## Product Change Notice

Change of Final Test site to ASE-M

BCM89610A2BMLGT

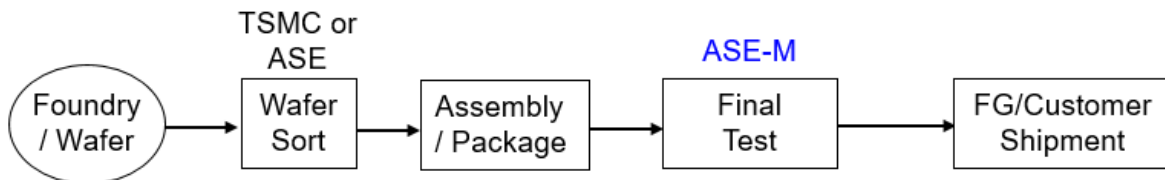
Electrical Final Testing (FT) is currently performed on this product at UTAC-SG (Singapore). Broadcom will move to ASE-M (Malaysia) as the source for FT. There is no change to the Foundry or Assembly locations or processes – see updated flow below.
